# INSTITUTO DOMINICANO DE AVIACIÓN CIVIL

### SECCIÓN DE GESTIÓN DE ESPACIO AÉREO

**PROPOSAL FOR AMENDMENT**

UL339

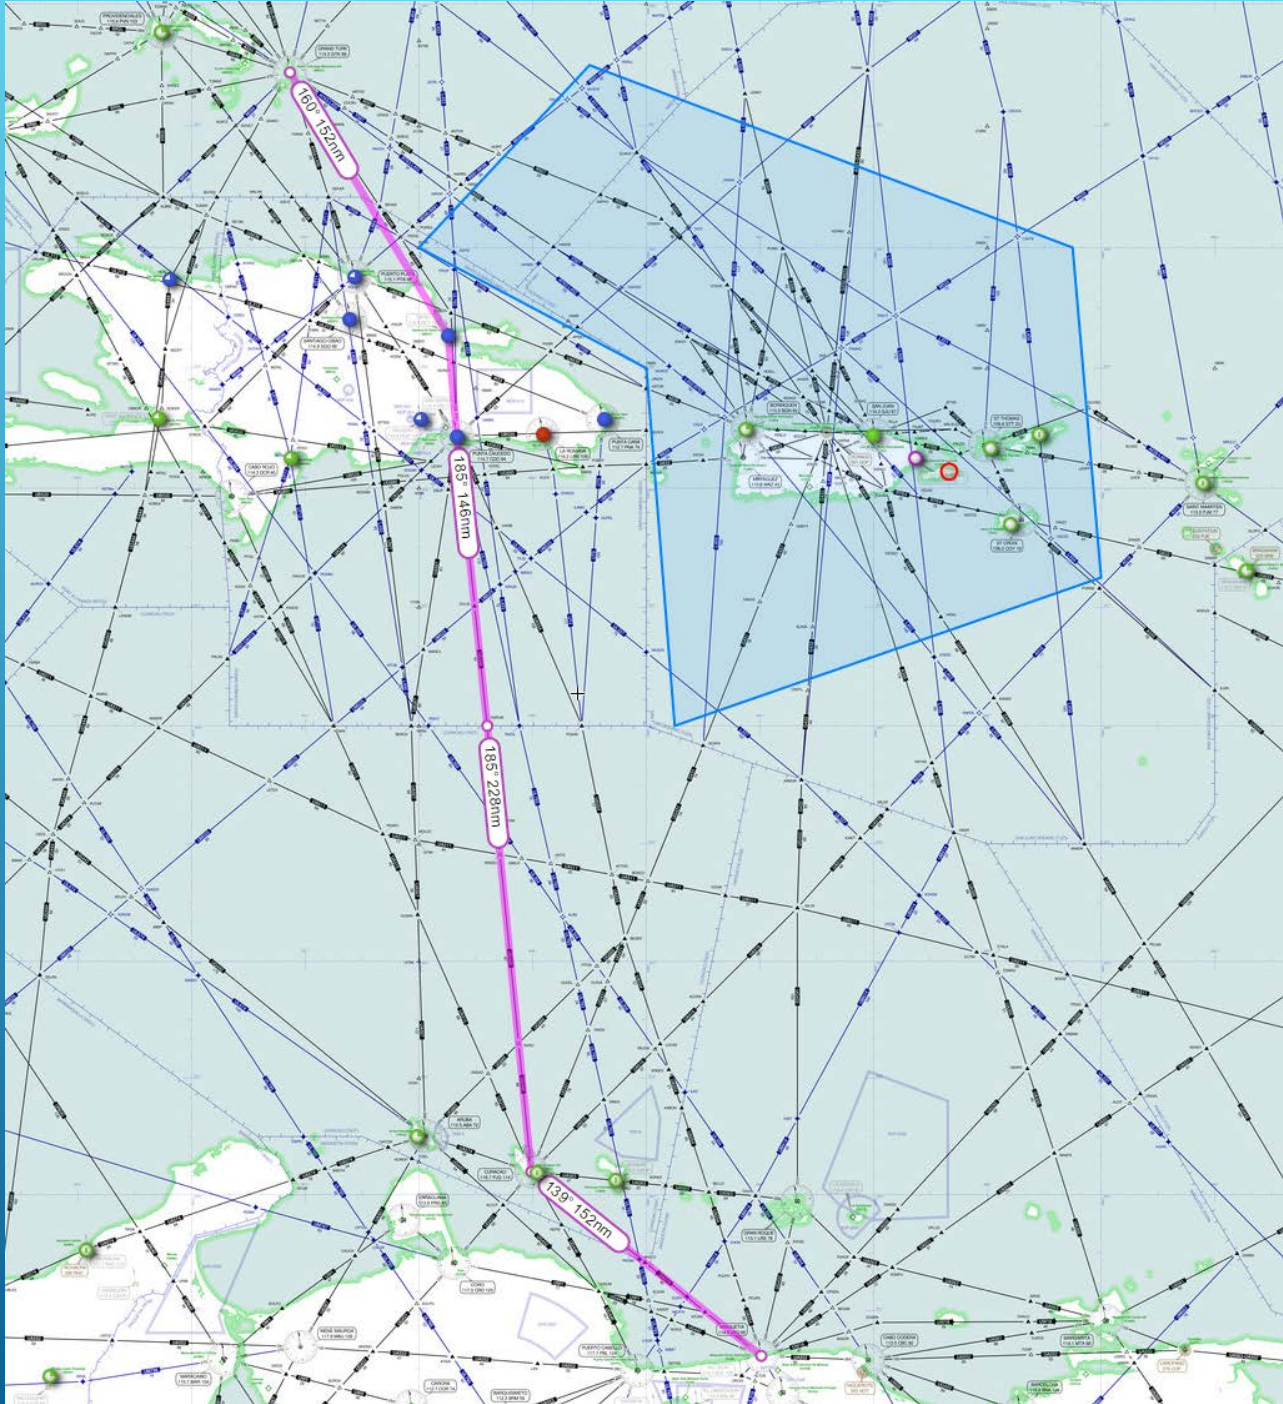
## UL339 sustituye UG446

<b>PUNTO SIGNIFICATIVO SIGNIFICANT POINT</b>	<b>LATITUD LATITUDE</b>	<b>LONGITUD LONGITUDE</b>
<b>GTK/VOR</b>	21° 26' 58.8''N	071° 08' 03.6''W
<b>JARED</b>	20° 23' 54.8''N	070° 27' 03.5''W
<b>DCY/VOR</b>	19° 16' 14''N	69° 26' 27''W
<b>CDO/VOR</b>	18° 26' 28.8''N	69° 40' 10.2''W
<b>KARUM</b>	16° 00' 38.4''N	69° 24' 21''W
<b>PJG/VOR</b>	12° 12' 27.6''N	69° 01' 29.4''W
<b>VSJ/VOR</b>	11° 10' 29.4''N	68° 25' 40.8''W
<b>MIQ/VOR</b>	10° 37' 03''N	66° 59' 59.4''W

UL342

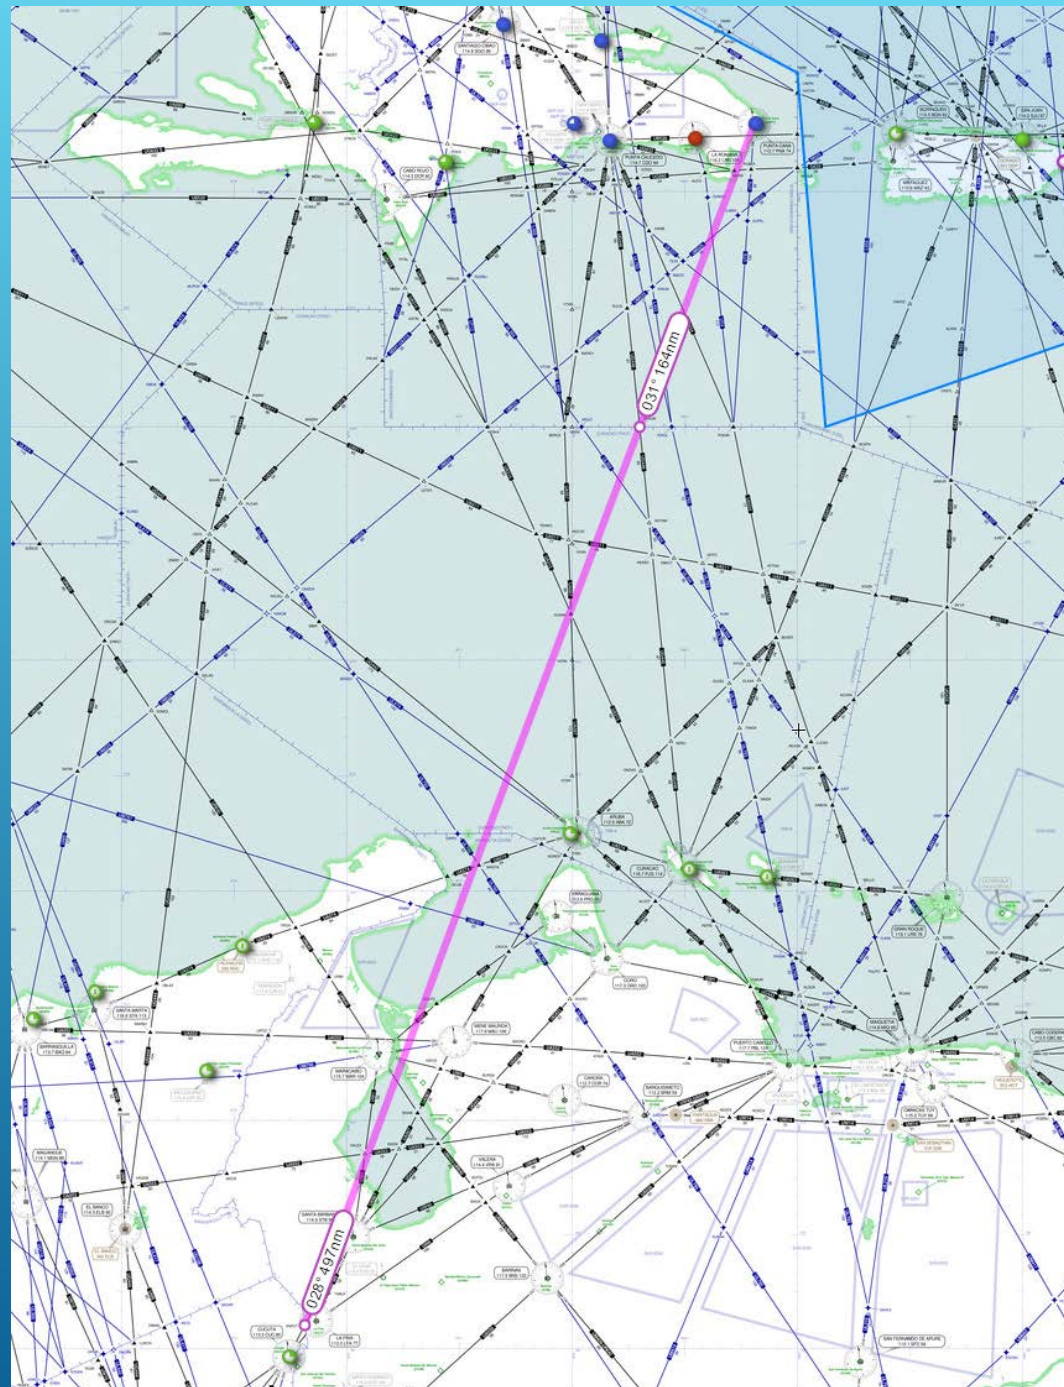
## UL342 nueva de Colombia a PNA

<b>PUNTO SIGNIFICATIVO SIGNIFICANT POINT</b>	<b>LATITUD LATITUDE</b>	<b>LONGITUD LONGITUDE</b>
<b>ENPUT</b>	08° 12' 24''N	072° 22' 24''W
<b>KARUM</b>	16° 00' 00''N	069° 24' 00''W
<b>ABREU</b>	16° 31' 27.16''N	069° 11' 28.9''W
<b>FIDEL</b>	16° 59' 30.39''N	069° 00' 15.43''W
<b>YOREL</b>	17° 36' 13.46''N	068° 45' 28.1''W
<b>PNA/VOR</b>	18° 34' 02''N	068° 23° 00''W

# UL349

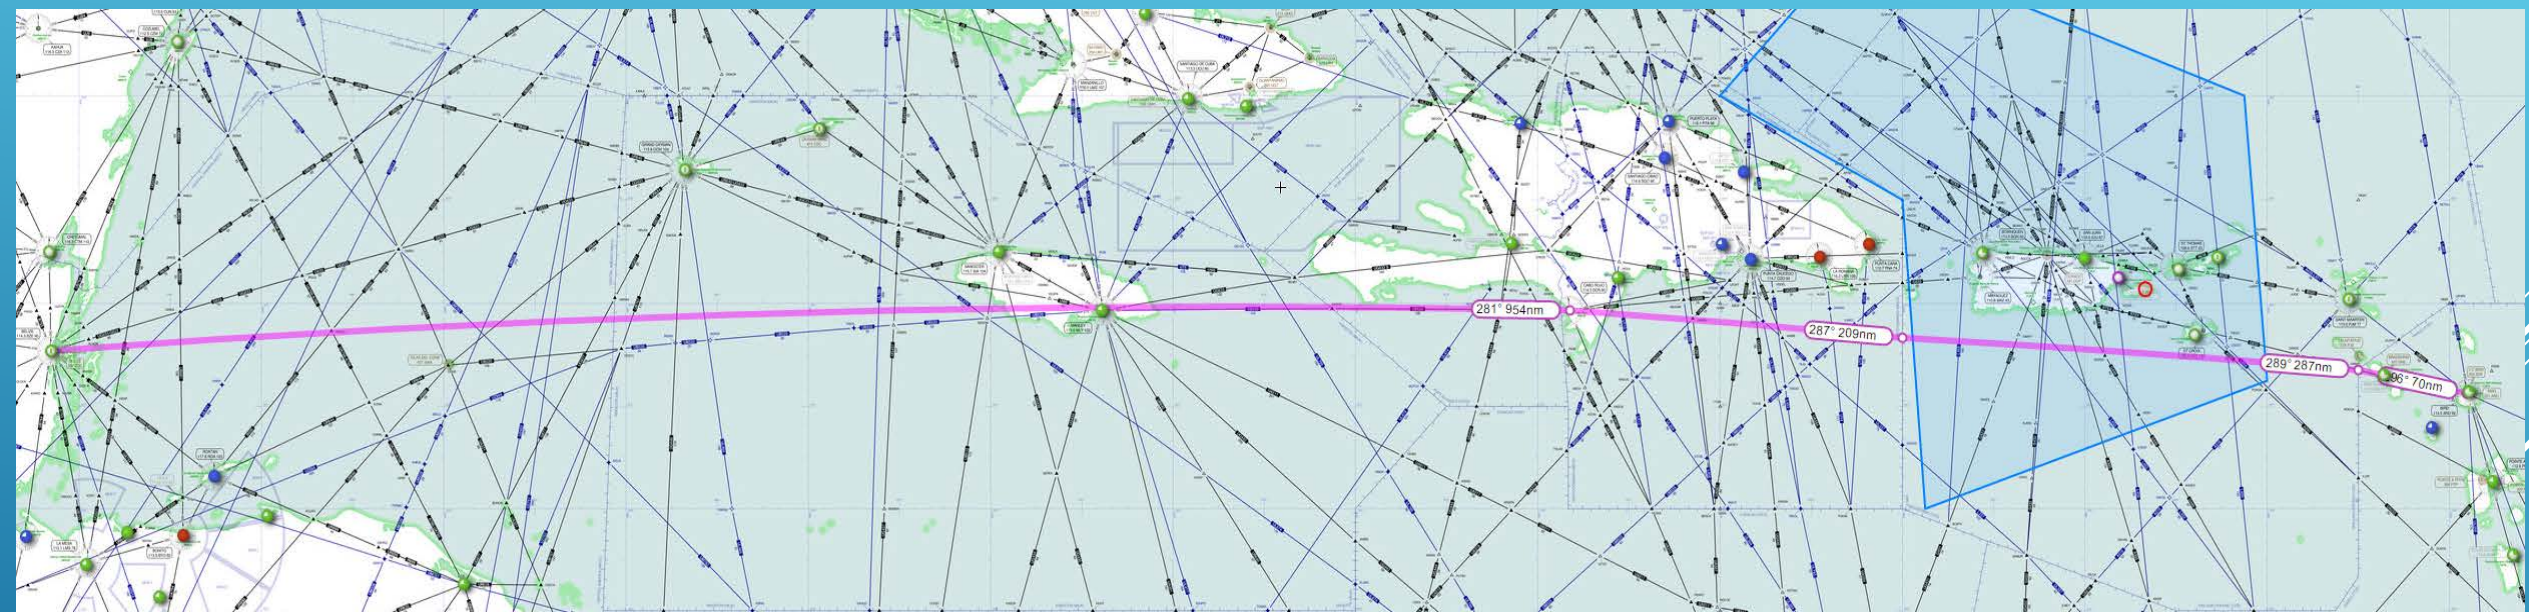
## L349 sustituye UG633/UG880

<b>PUNTO SIGNIFICATIVO SIGNIFICANT POINT</b>	<b>LATITUD LATITUDE</b>	<b>LONGITUD LONGITUDE</b>
<b>ANU/VOR</b>	17° 07' 33''N	061° 48' 01''W
<b>GABAR</b>	17° 21' 12.0''N	063° 00' 00''W
<b>GESSO</b>	17° 29' 37.76''N	065° 46' 42.88''W
<b>SATOE</b>	17° 40' 00''N	068° 00' 00''W
<b>ARIAS</b>	17° 46' 29.75''N	069° 22' 31.62''W
<b>IDACO</b>	17° 50' 50.66''N	070° 22' 20.69''W
<b>DCR/VOR</b>	17° 55' 56.28''N	071° 38' 52.19''W
<b>OBSIS</b>	17° 50' 58.9''N	74° 8' 7.27''W
<b>UMAKA</b>	18° 03' 18''N	82° 07' 24''W
<b>BZE/VOR</b>	17° 32' 24''N	088° 18' 48''W

# UL468

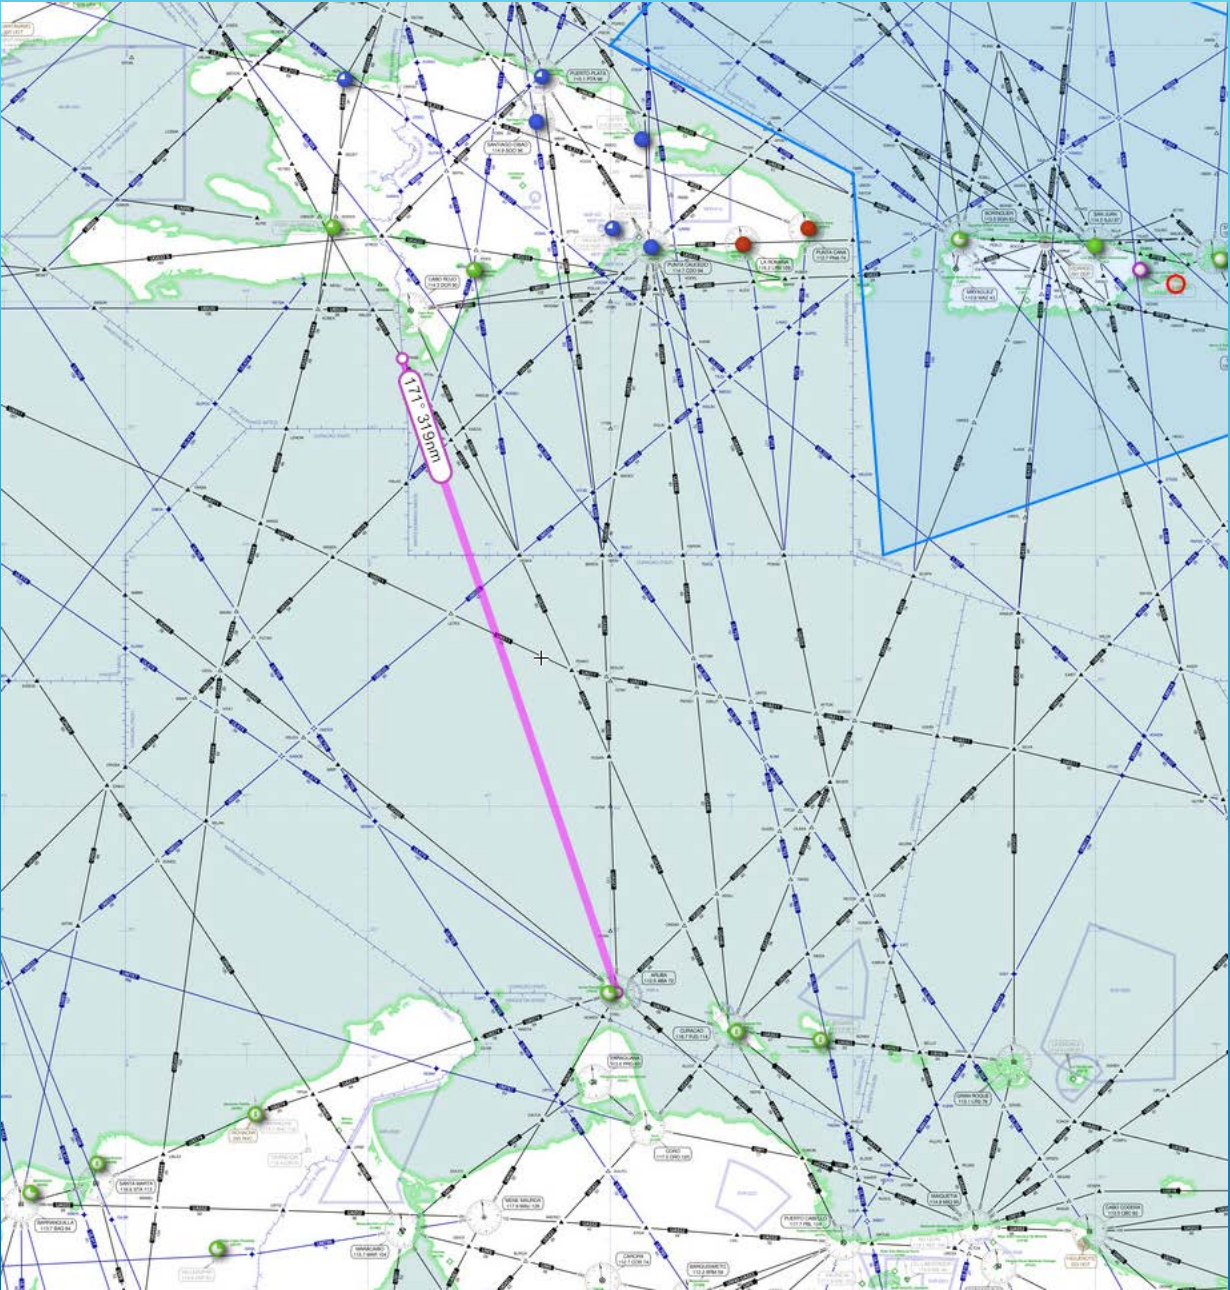
## UL468 nueva de PIGBI a ABA

<b>PUNTO SIGNIFICATIVO SIGNIFICANT POINT</b>	<b>LATITUD LATITUDE</b>	<b>LONGITUD LONGITUDE</b>
<b>PIGBI</b>	17° 41' 21.38''N	071° 43' 40.7''W
<b>ALSYN</b>	16° 48' 44''N	071° 25' 08.9''W
<b>JULIO</b>	16° 00' 00''N	071° 08' 08.6''W
<b>ABA/VOR</b>	12° 30' 18''N	069° 56' 36''W

# UL577

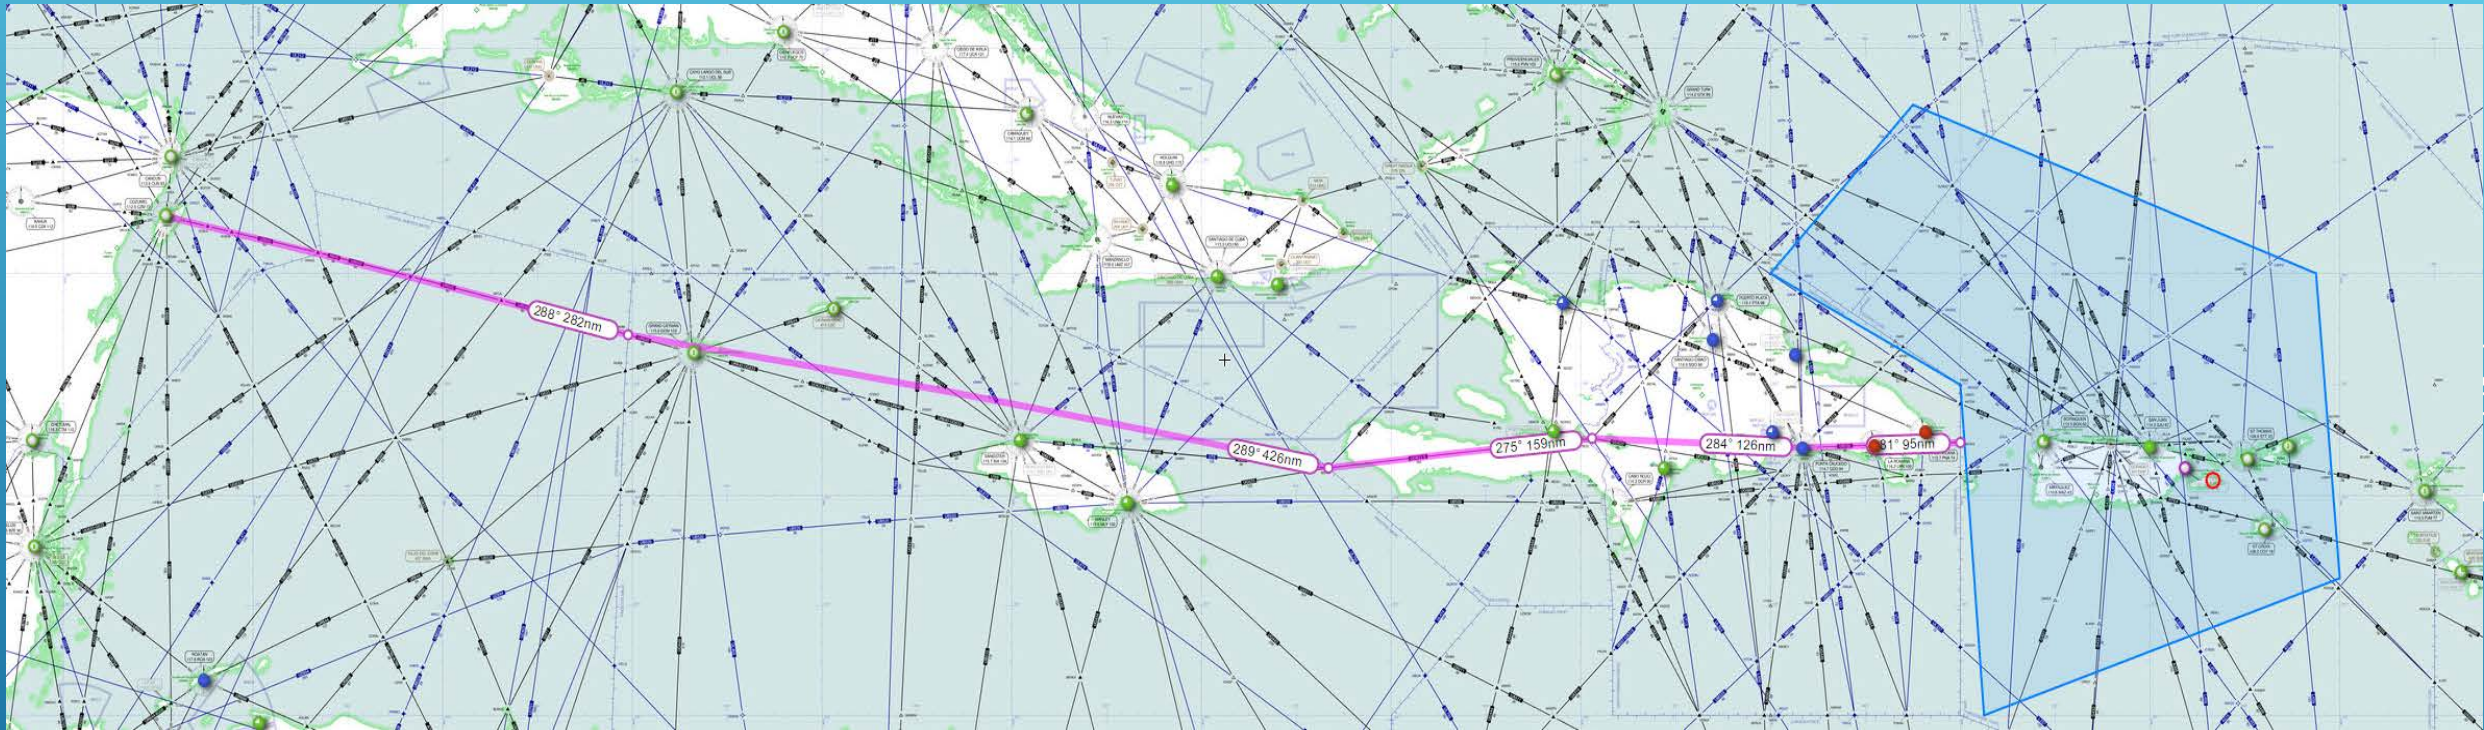
## UL577 sustituye UB520/UG633

<b>PUNTO SIGNIFICATIVO SIGNIFICANT POINT</b>	<b>LATITUD LATITUDE</b>	<b>LONGITUD LONGITUDE</b>
<b>ANU/VOR</b>	17° 07' 33''N	061° 48' 01'' W
<b>ELOPO</b>	17° 39' 00.2''N	062° 33' 15.8''W
<b>PJM VOR/DME</b>	17° 28' 25.70''N	063° 07' 05.78''W
<b>STT VOR/DME</b>	18° 21' 20.94''N	065° 01' 28.40''W
<b>ANTEX</b>	18° 29' 00''N	068° 00' 00''W
<b>CDO/VOR</b>	18° 25' 58.57''N	069° 40' 02.38''W
<b>ETBOD</b>	18° 31' 00''N	071° 53' 00''W
<b>BENET</b>	18° 15' 00''N	074° 39' 42''W
<b>MAMBI</b>	19° 27' 00''N	082° 02' 48''W
<b>CZM</b>	20° 81' 18''N	086° 55' 48''W

UL216

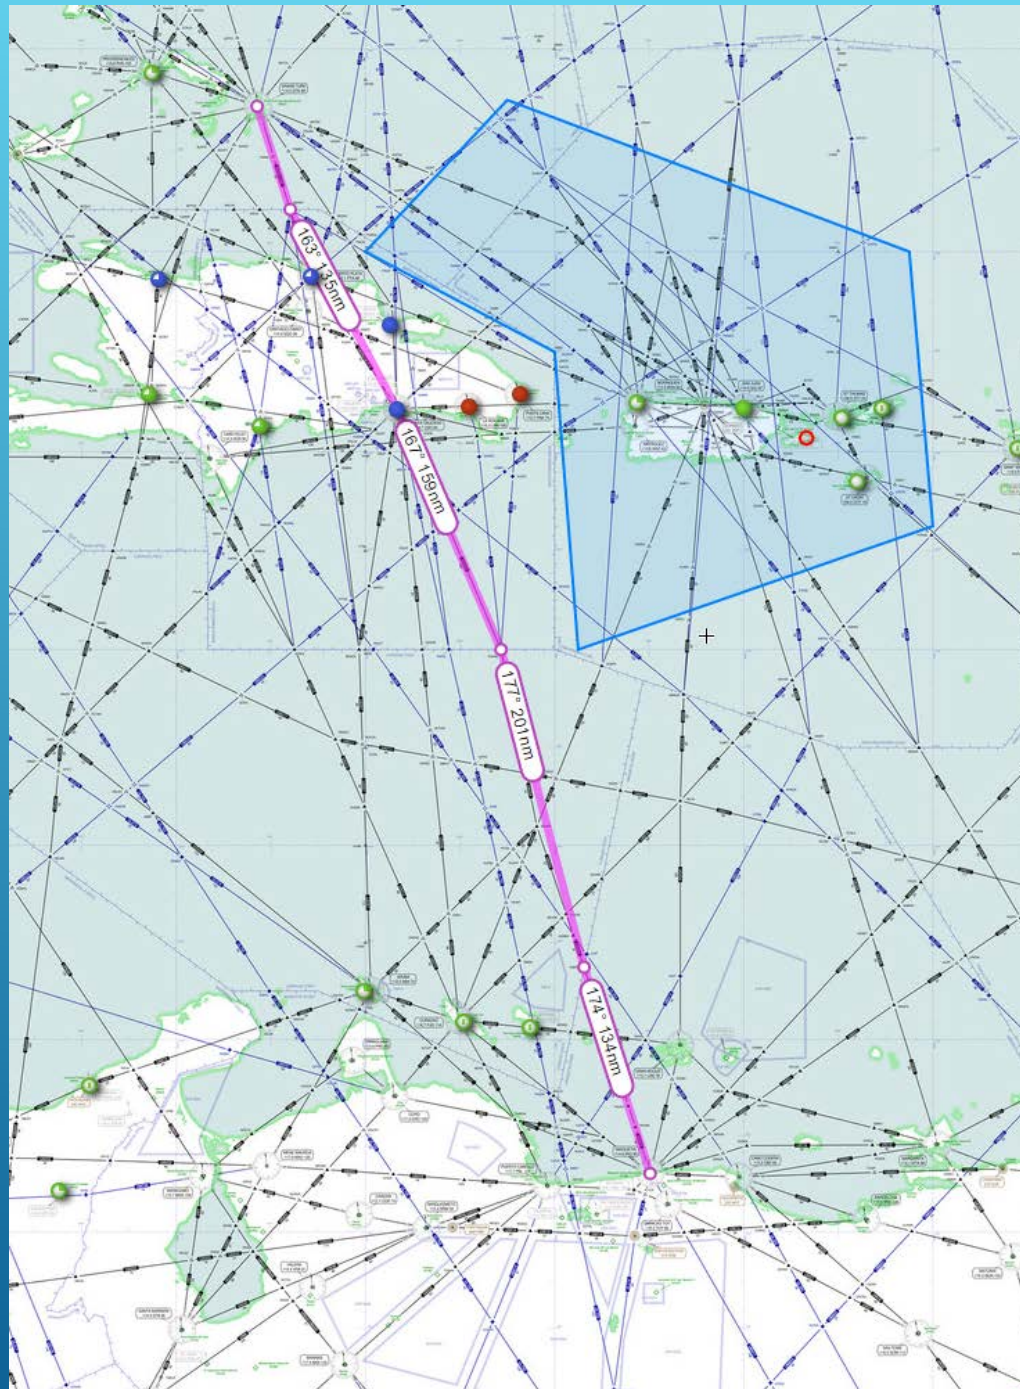
## UL216 sustituye la UA554

<b>PUNTO SIGNIFICATIVO SIGNIFICANT POINT</b>	<b>LATITUD LATITUDE</b>	<b>LONGITUD LONGITUDE</b>
<b>GTK/VOR</b>	21° 26' 58.8''N	071° 08' 03.6''W
<b>SEKAR</b>	20° 25' 00''N	070° 47' 42''W
<b>PTA/VOR</b>	19° 45' 33.00''N	070° 34' 14''W
<b>CDO/VOR</b>	18° 25' 58.57''N	069° 40' 02.38''W
<b>POKAK</b>	16° 00' 00''N	068° 34' 00''W
<b>KABON</b>	14° 11' 58.2''N	068° 12' 02.4''W
<b>MIQ/VOR</b>	10° 36' 29.4''N	066° 59' 51.6''W
